SCHROEDER ELEMENTARY SCHOOL

ADDENDUM NO. 1
TO THE
PLANS AND SPECIFICATIONS
FOR
SCHROEDER ELEMENTARY SCHOOL
DSA 04-101569

ADDENDUM NO. 2
TO THE
PLANS AND SPECIFICATIONS
FOR
SCHROEDER ELEMENTARY SCHOOL
DSA 04-101569

ADDENDUM NO. 3
TO THE
PLANS AND SPECIFICATIONS
FOR
SCHROEDER ELEMENTARY SCHOOL
DSA 04-101569

DEMOLITION FLOOR PLANS BUILDINGS #1, #2, #3 AND #4

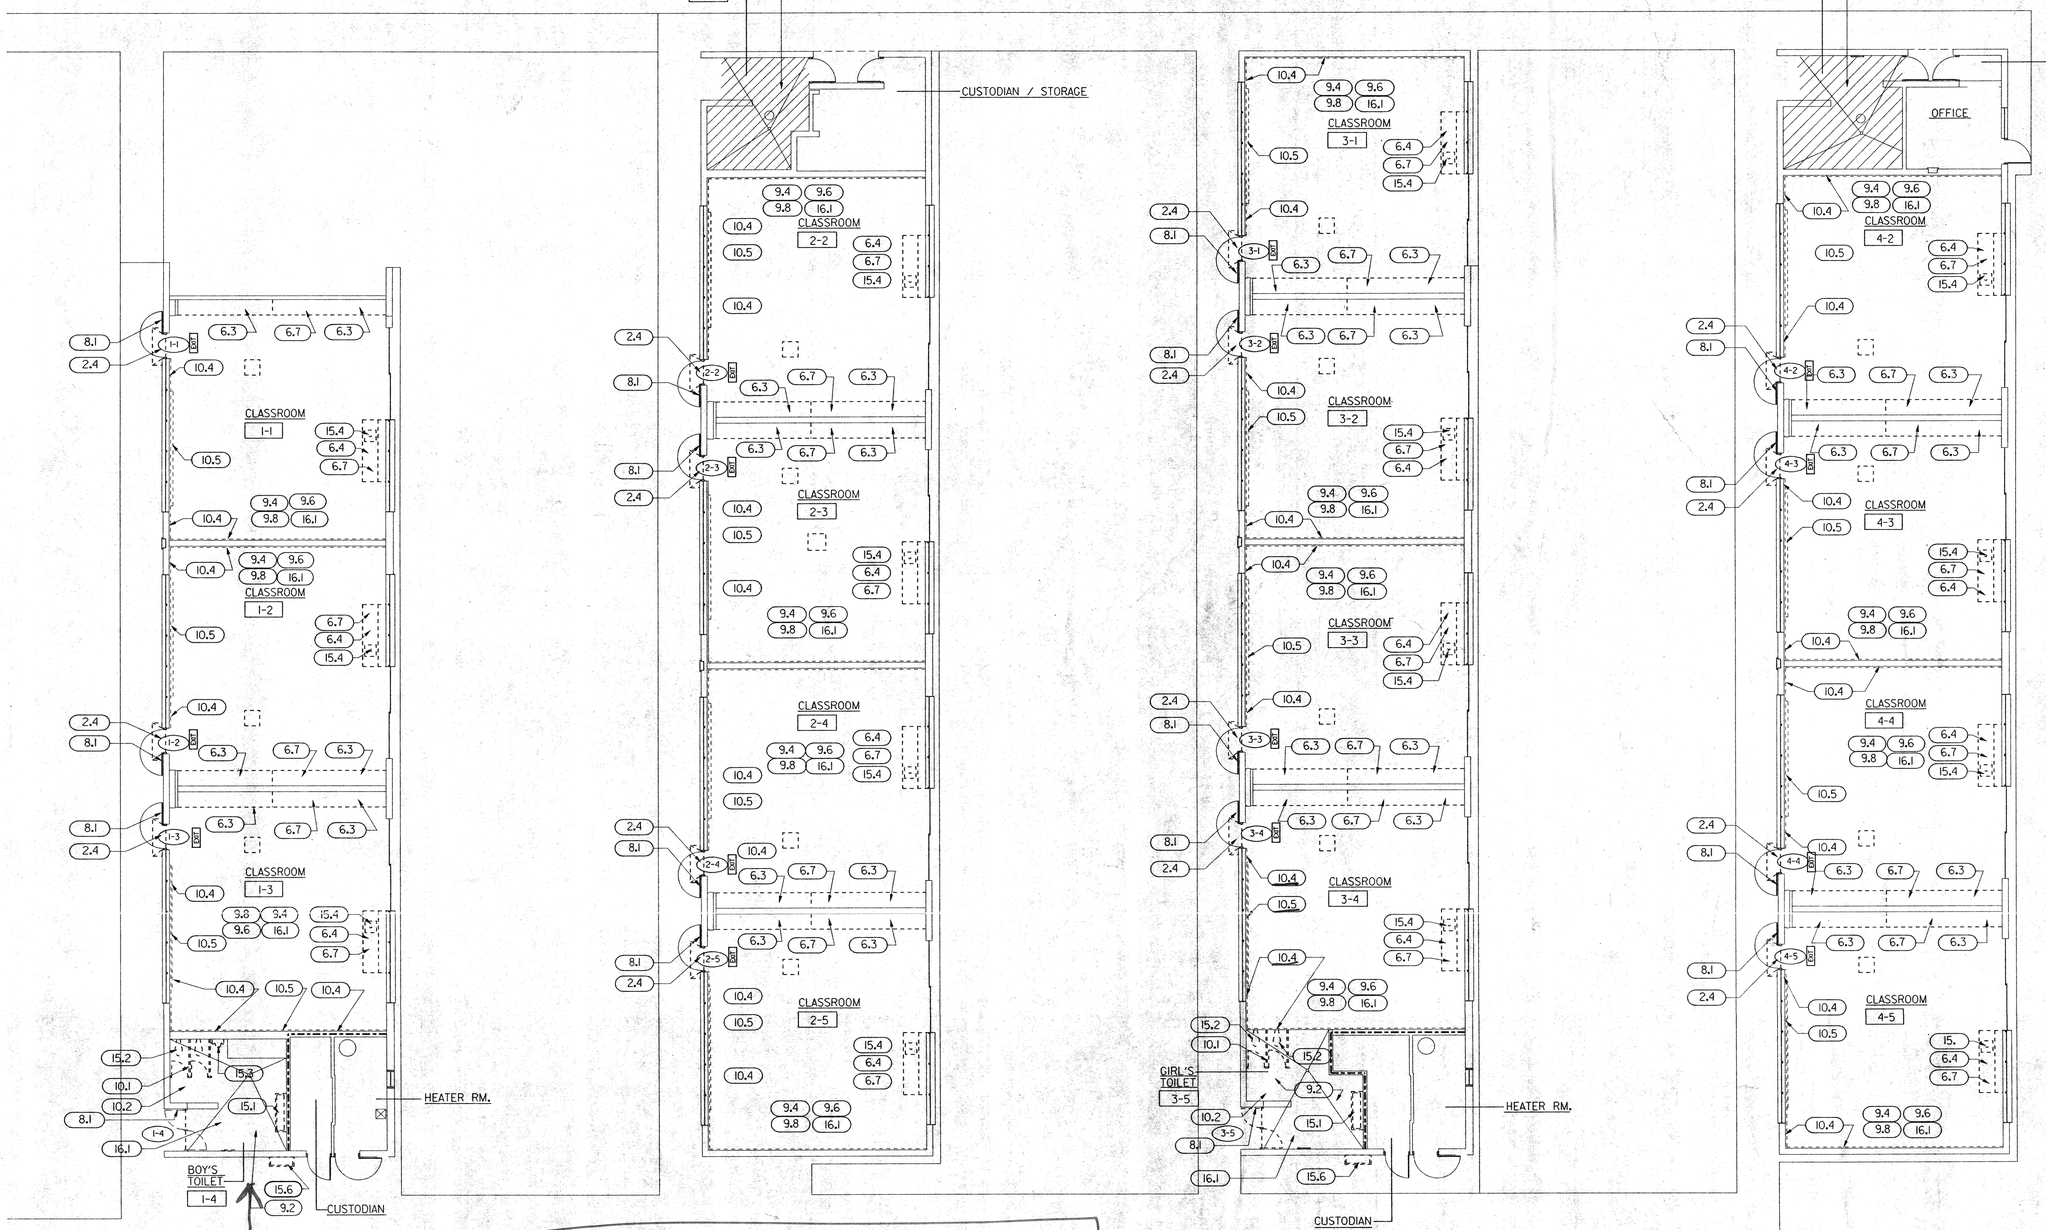
1. **ADDENDUM DRAWING AD3-4** is issued with this Addendum #3 to show the addition of Doors #1-5, #1-6, #2-6, #2-7, #3-6, #3-7, #4-6, and #4-7.
2. REVISE Room Name 'Classroom' No. 2-5 to read "Library". REVISE Room Name 'Classroom' No. 2-4 to read "Computer Lab".
3. ADD Door 2-8 in wall between Library and Computer Lab. ADD Demolition Keynote 6.1 to Door 2-8. ADD Construction Keynotes 8.7 and 9.21.

3.1 SHEET D-2.1 - ADD. NO. 2
1. On Sheet D-2.1 – Room I-4, Demolition Keynote applies for ALL existing urinals, both floor-mounted and wall-hung.

3.1 SHEET D-2.1 - SHEET A-2.1 -
1. **ADDENDUM DRAWING AD1-1** is issued with this Addendum #1 to show revised interior work at all Classrooms.

4. ADD new Construction Keynote 9.21 to read as follows:
"9.21 Patch and repair existing interior Portland Cement plaster. Finish to align with existing adjacent plaster surfaces to remain."

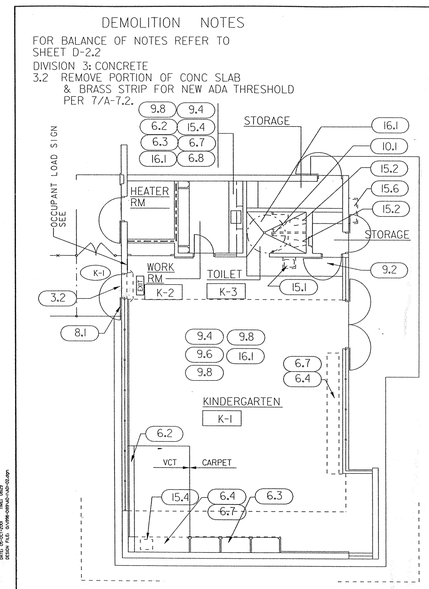
9. **ADDENDUM DRAWING AD2-2** is issued with this Addendum #2 to show demolition and new work at the Multi-Purpose Toilet Rooms.

SCALE: NO SCALE	ADDENDUM NO. 3	DSA#: 04-101569	FILE#: 30-43
SEISMIC ANCHORAGE DETAIL			DATE: 11/1/01
NTD ARCHITECTS	ALTERATIONS TO SCHROEDER ELEMENTARY SCHOOL WESTMINSTER SCHOOL DISTRICT WESTMINSTER, CALIFORNIA		JOB: 1998-0189
		AD3-7	REFERENCE

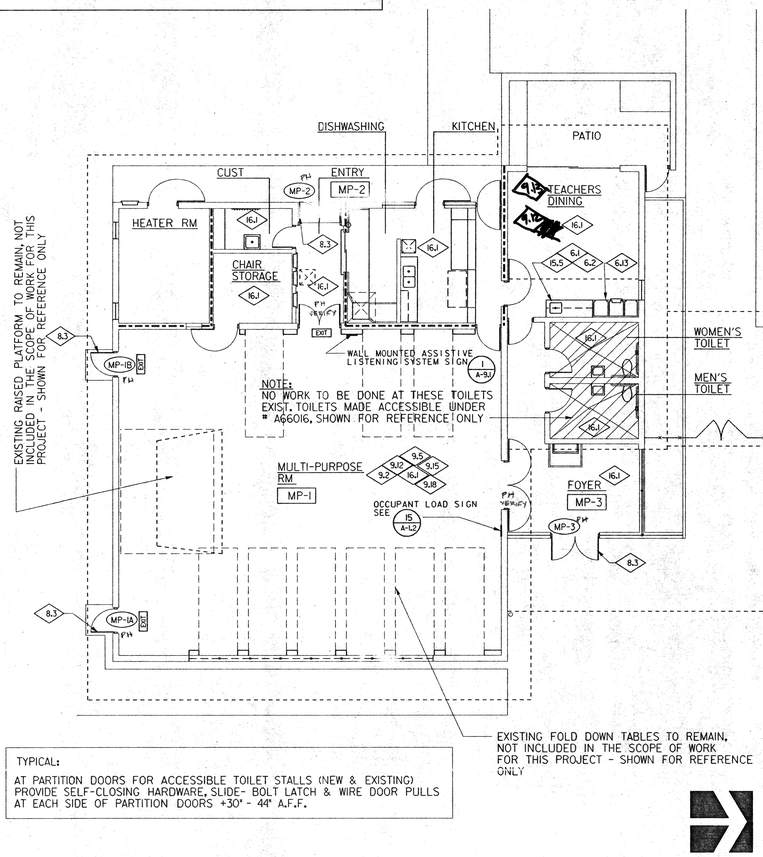
17. **ADDENDUM DRAWING AD3-7** is issued with this Addendum #3 to show anchorage for free-standing shelving.

A / E-1.1 **PARTIAL SINGLE LINE DIAGRAM**
NOT TO SCALE

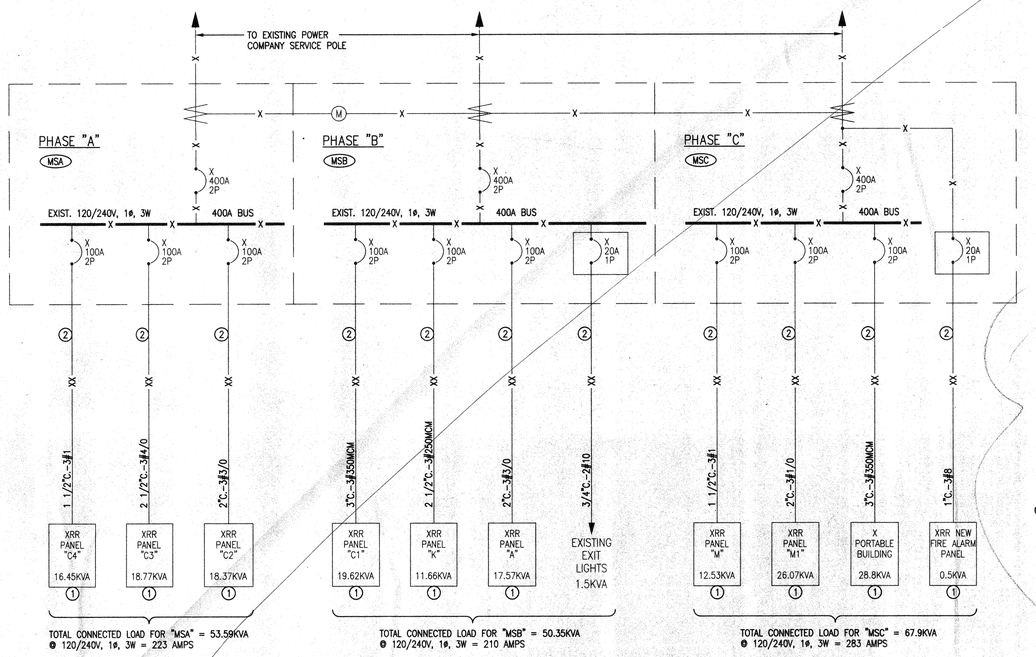
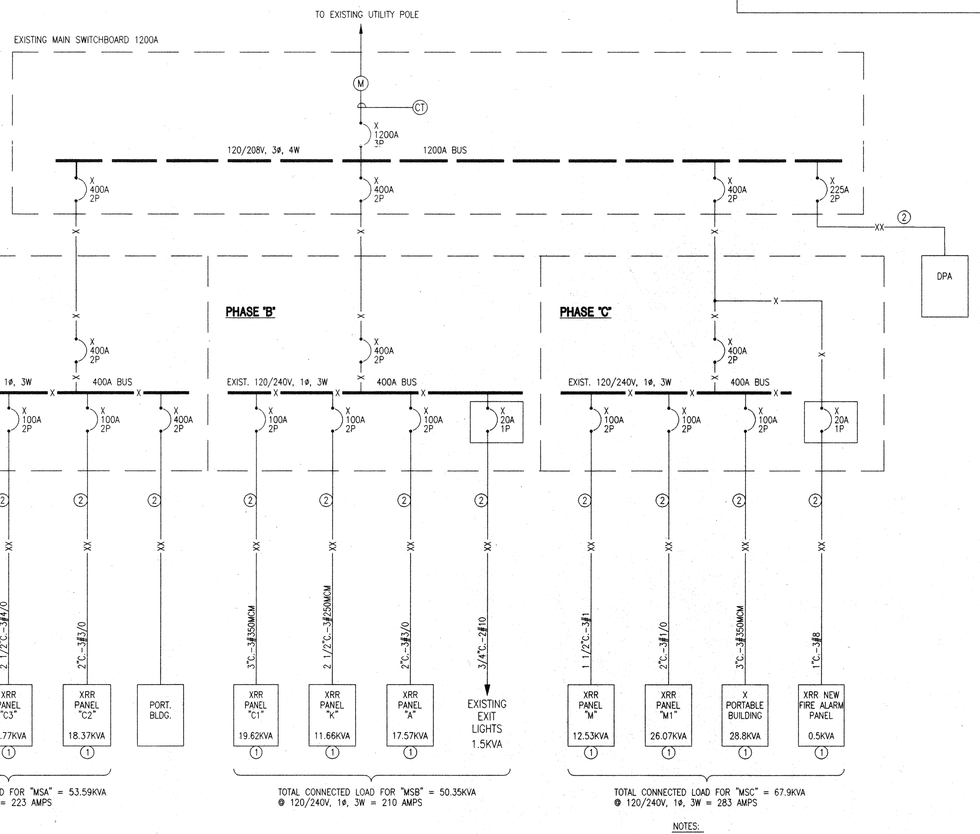
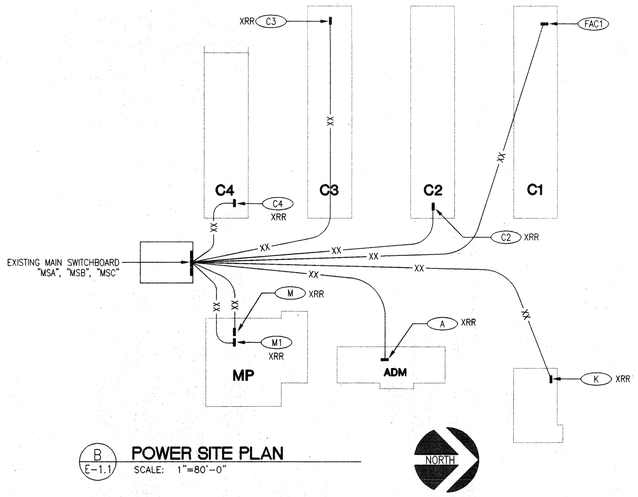
6. **ADDENDUM DRAWING AD2-3** is issued with this Addendum #2 to show the following:
   a) CHANGE Bldg. designations C-4 to 1, C-3 to 2, C-2 to 3, and C-1 to 4.
   b) ADD General Notes #4 and #5.

15. CHANGE General Note #4 to refer to Note #1 on Sheet E-2.1.1.
16. CHANGE General Note #5 and ADD new Notes #6 and #7 to read as follows:
    "5. Remove all existing switch(es) and provide a new single switch to ADA requirements in all areas affected by modernization.
    "6. The intent of the lighting drawings is for the contractor to reuse existing conduits wherever possible when conductors cannot be removed, provide new conduit, wire and all necessary connections to match existing conditions.
    "7. There shall be no roof penetrations unless authorized by the Architect."

16. ADDENDUM DRAWING AD1-9 is issued with this Addendum #1 to show:
   a. Revised "wiremold" symbols list.
   b. Revised partial single lines diagram.
   c. Revised and added details.

SHEET OF .
AD1-10
(E-2.1.1)

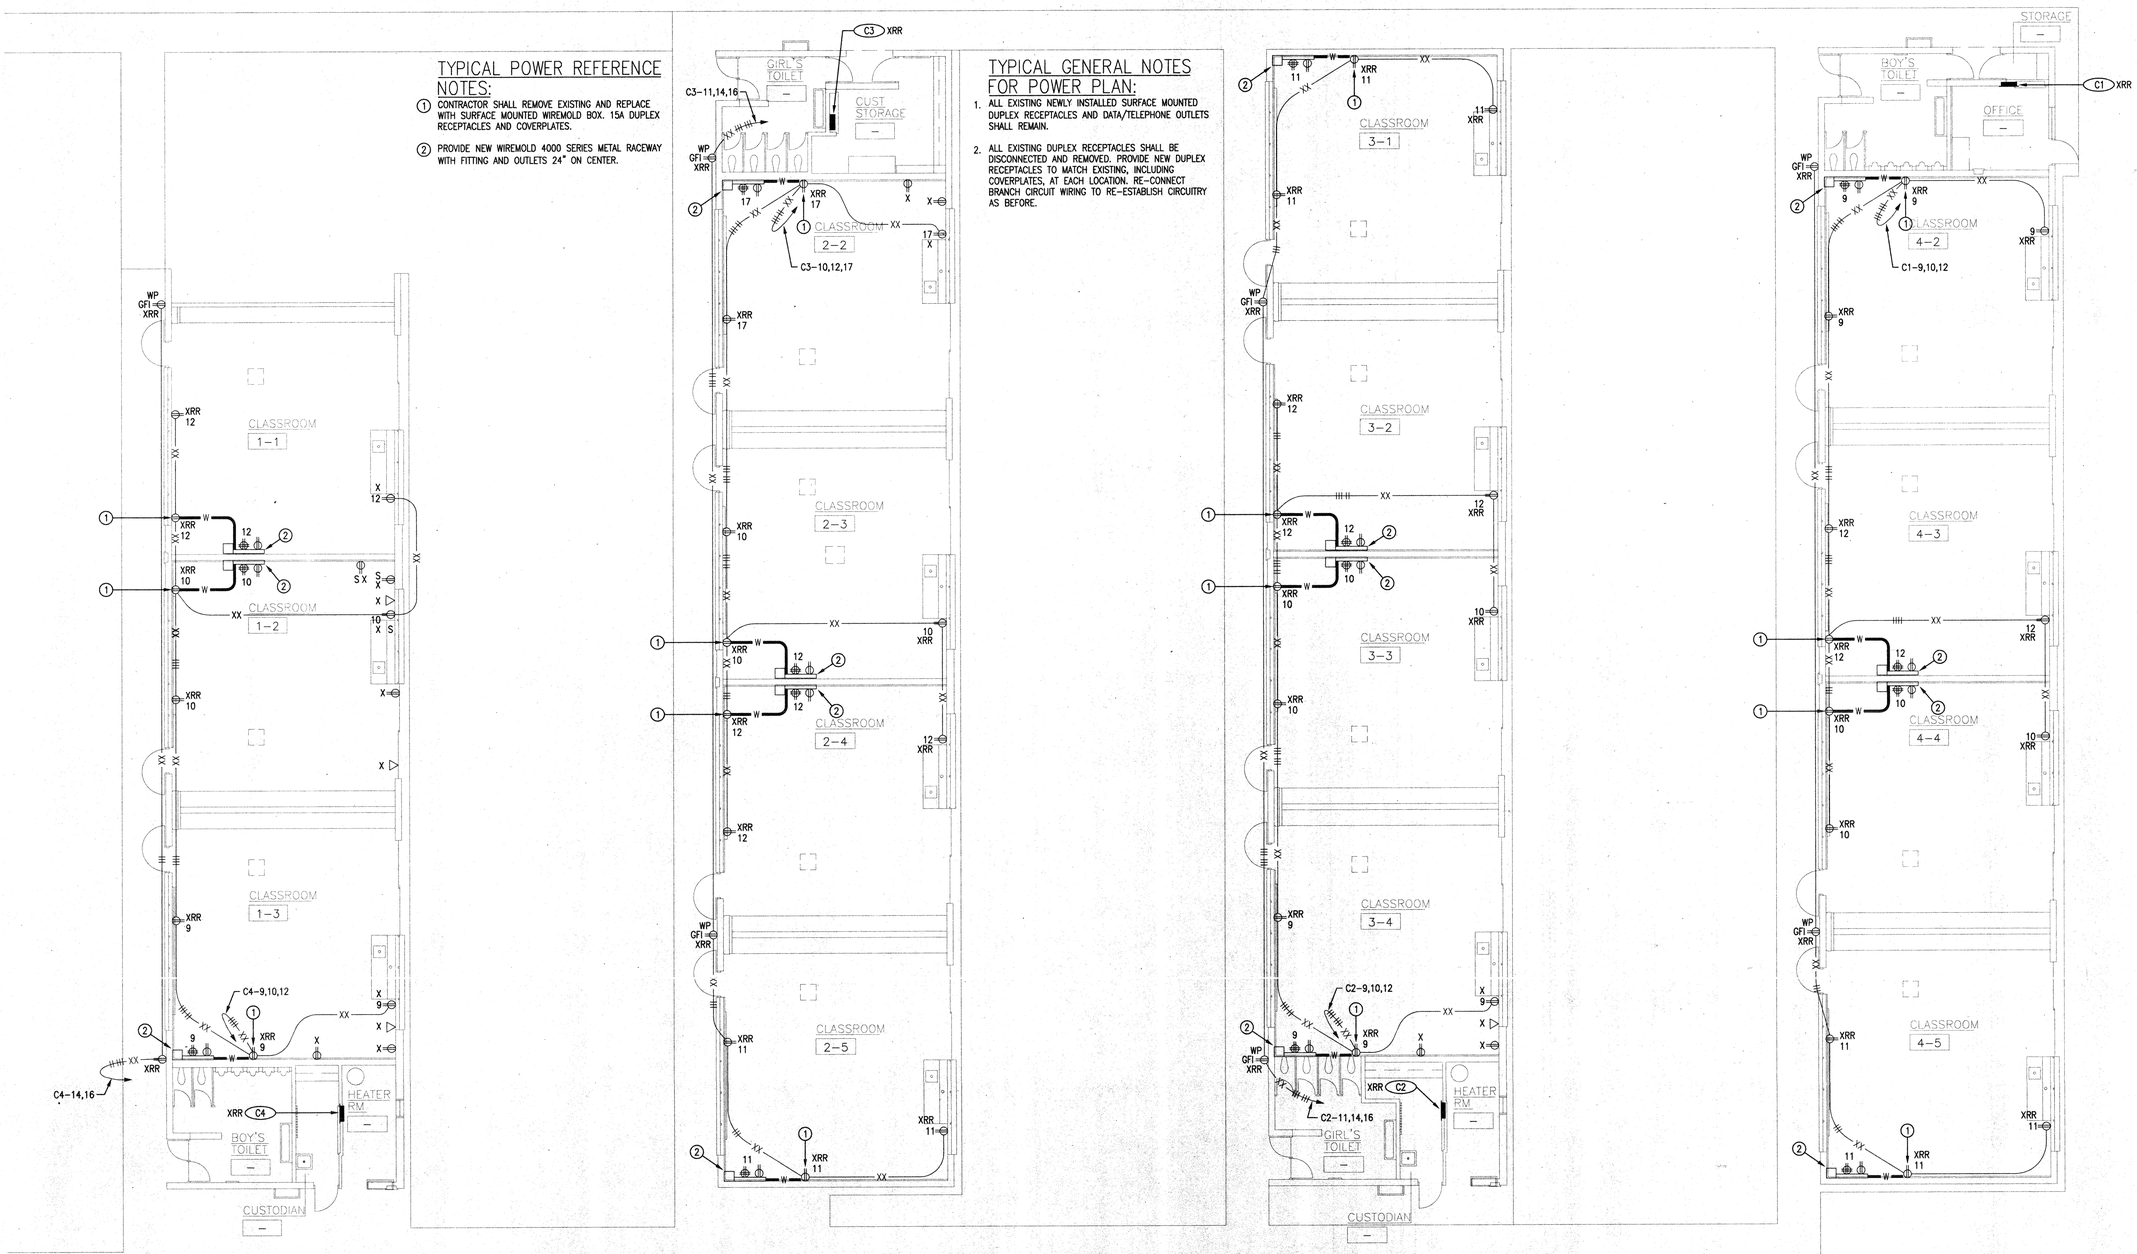
7. **ADDENDUM DRAWING AD2-4** is issued with this Addendum #2 to show the following:

a) CHANGE location of Panel 'C1' to Bldg. 4.
b) CHANGE location of Panel 'C2' to Bldg. 3.
c) CHANGE designation of Panel 'D' to 'C4'.

17. **ADDENDUM DRAWING AD1-10** is issued with this Addendum #1 to show:
    a. Added electrical notes.
    b. Revised lighting layout.
    c. Revised panel schedules for Panels "C1" and "C2".
    d. Revised buildings name designation.
